# SERVICE NOTES

# National

Service Bulletin FSN-30

Subject: NC-300 Changes

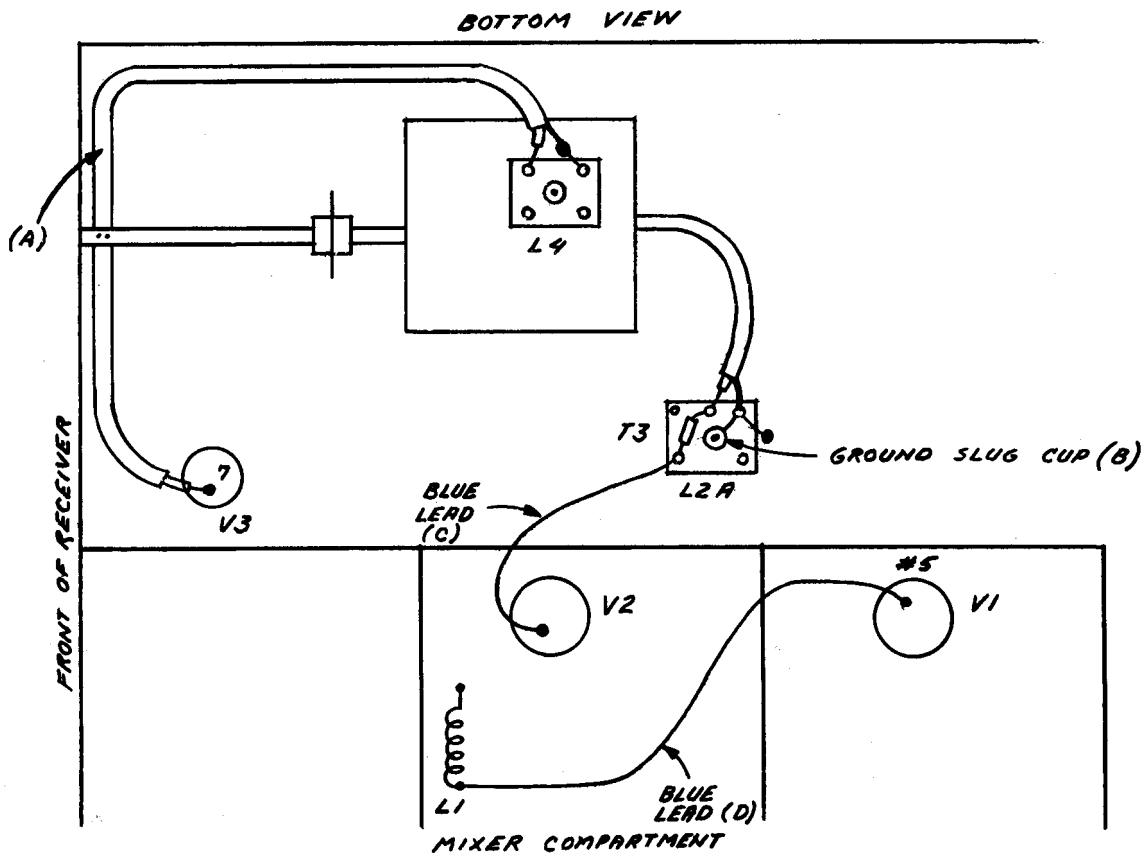
A shielded lead should be constructed as shown below:

- A. Replace shielded lead from L4 to grid of second converter, V3 with above lead, placing it under phasing control shaft as shown in the pictorial diagram below.

SUBJECT: NC-300 C6 Changes

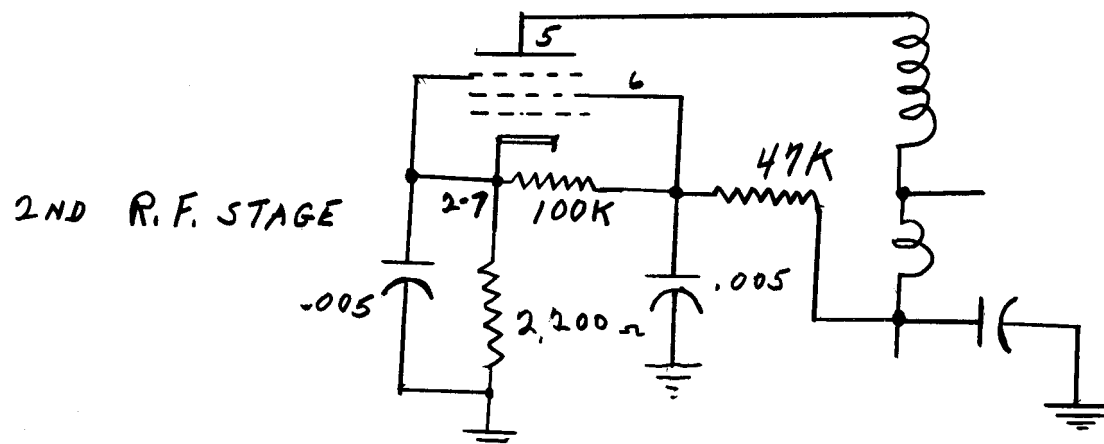
The following changes are recommended in the 6-meter converter to reduce cross-modulation:

Change cathode resistor in 6AK5 2nd R.F. amplifier stage from 470 ohms  $\frac{1}{2}$  watt to 2200 ohms  $\frac{1}{2}$  watt

A 100,000 ohm  $\frac{1}{2}$  watt resistor should be connected between Pin #6 and Pin #2 - 7 of the same 6AK5 2nd R.F. stage

Revised circuit below:

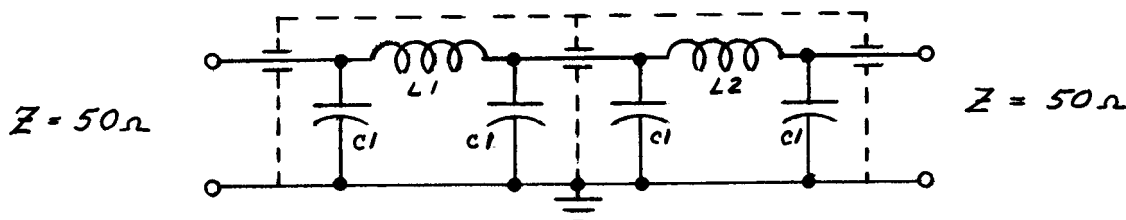
In certain metropolitan areas, I.T.V. is experienced on the 21 mc, 28 mc and X bands of the NC-300. This can be minimized by proper selection of antenna and the use of a low pass filter shown in the diagram below. This filter should be inserted in series with the antenna and located as close as practicable to the antenna terminals on the back of the chassis. A good earth ground helps considerably.

$L_1$  = .4 uh      10 Turns #20 on 3/8" form spaced 1/2"

$C_1$  = 80 uuf Ceramic

Bulletin Number FSN-48

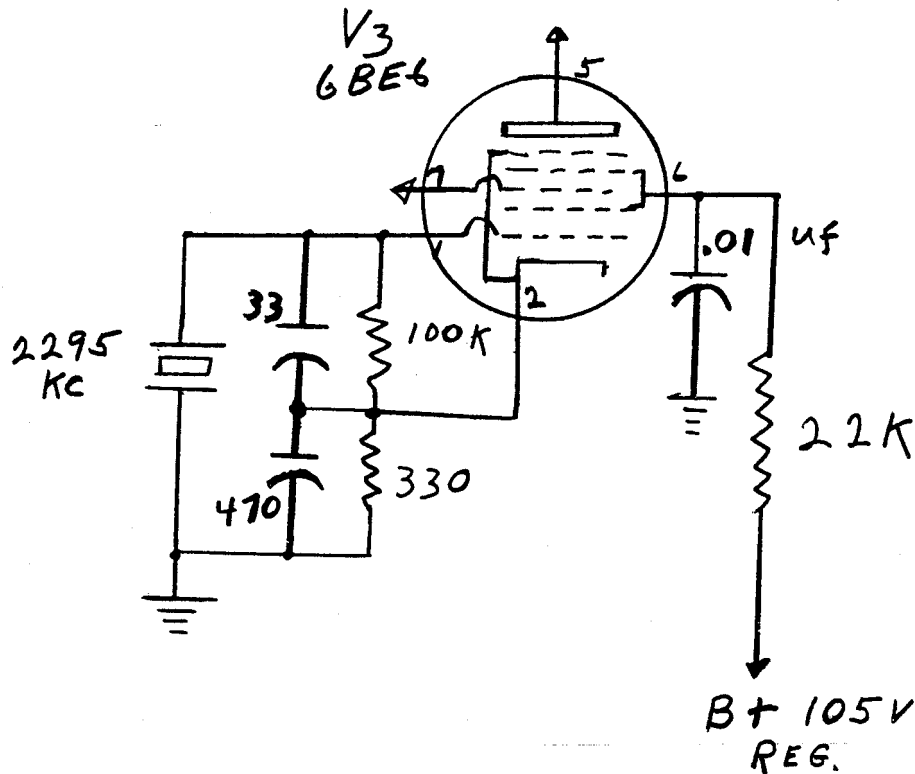
In these instances we recommend crystal control of the second conversion oscillator as per the attached schematic. It should be remembered that there are now two crystals in the circuit which must be properly coordinated if the receiver is to work at maximum efficiency. Normal production tolerances in the grinding of the crystals may allow a situation to exist where the difference in frequency of the crystal in the crystal filter (2215 kc) and the crystal in the second conversion oscillator (2295 kc) is not exactly 80 kc (second IF).
